TAB Punch List

Prepared by Ben Searles

May 17, 2025

IMG_1115

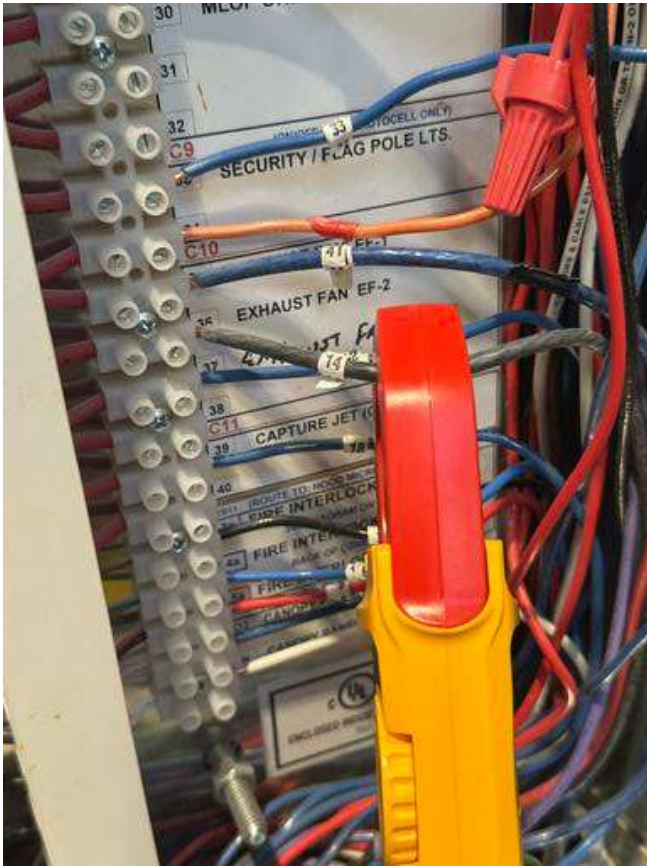
The wiring into the T500 panel for all exhaust fans needs to be verified and revised. The wires appear to be swapped between the fans. This was observed when all fans except for EF1 were turned off, but the wire for EF2 was the only live wire.
